Request of Class II Permissive Change

FCC ID: 2AOKB-T8220

This is to request a Class II Permissive Change for FCC ID: **2AOKB-T8220** originally granted on 07/15/2020

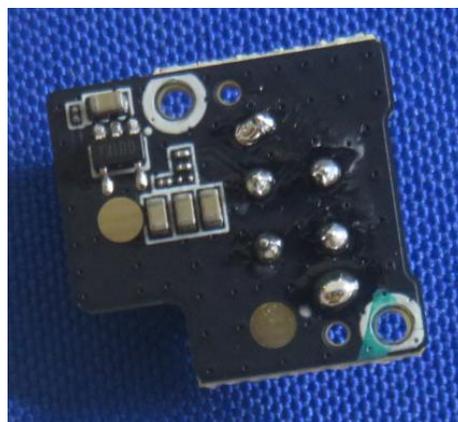
- (1) Changing the appearance.
- (2) Changing the Product Name to "Video Doorbell 1080p (Battery-Powered)".
- (3) Changing the model name "T8220" to "T8222".
- (4) Changing the Layout of the of the PIR board frame. (T8220_PIR_V01 to T8222_PIR_V01)
- (5) Changing the Master chip "HiSilicon HI 3518_ERNCV300" to "Ingenic T31".

Original T8220

New T8222

The changes are not related with the other RF parameters, only "SPURIOUS EMISSIONS" of T8222 were retested, other data were referred to the original report.
